TECHNICAL SERVICE BULLETIN

Technical Service Bulletin: 10-1279
Expiration Date: 2/25/2022

Forest River is alerting you to an issue involving certain 2021 Rockwood Lite and Flagstaff Lite Recreational Vehicles. Please see the information below, which describes the issue and provides you with details on the steps you should take to have your vehicle repaired.

TECHNICAL SERVICE BULLETIN 10-1297 REMEDY INSTRUCTIONS

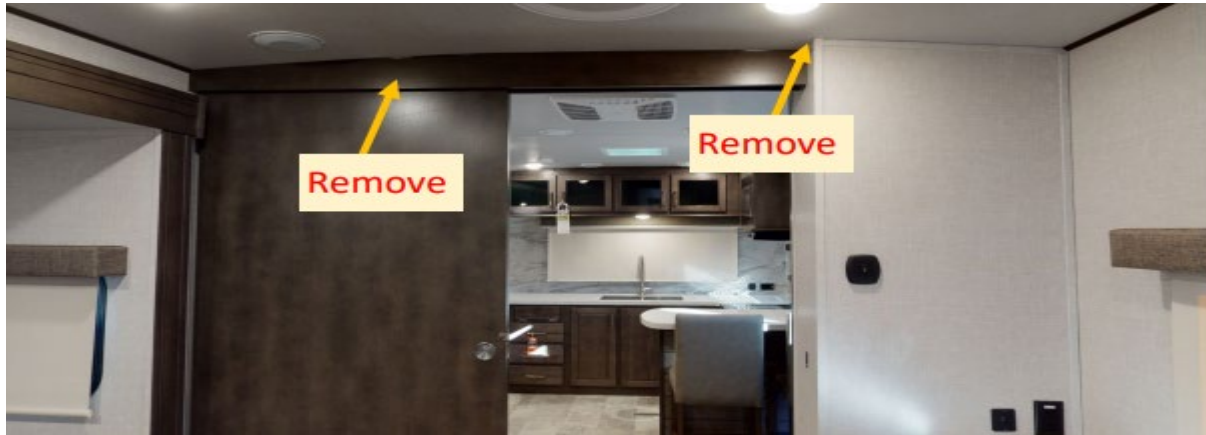
The pocket door header is missing a backer.

Make(s): Rockwood Lite & Flagstaff Lite Model(s): See below Model Year(s): 2021	Repair Code: SB-473-03-00-003989 Allotted Time: 1.0 hr. Inspection Code: Allotted Time: N/A Photo(s) Required: No
	Concern: Pocket door header is missing a backer.	Prior Authorization Required: No Part(s) Number: See below Part(s) Return: No

1. Remove trim on driver's side cabinet. Carefully pry, starting from the right side on the stile that is pin-nailed to the header on the bedroom side of the wall.

2. Add three (3) 3" screws through the header into the top 3/4" of the wall.

3. Clean the caulk off the ceiling and stile that was removed. Nail the stile back in place on the door header. Reseal the top of the stile to the ceiling with the correct color sealant. Finish by puttying the nail holes.
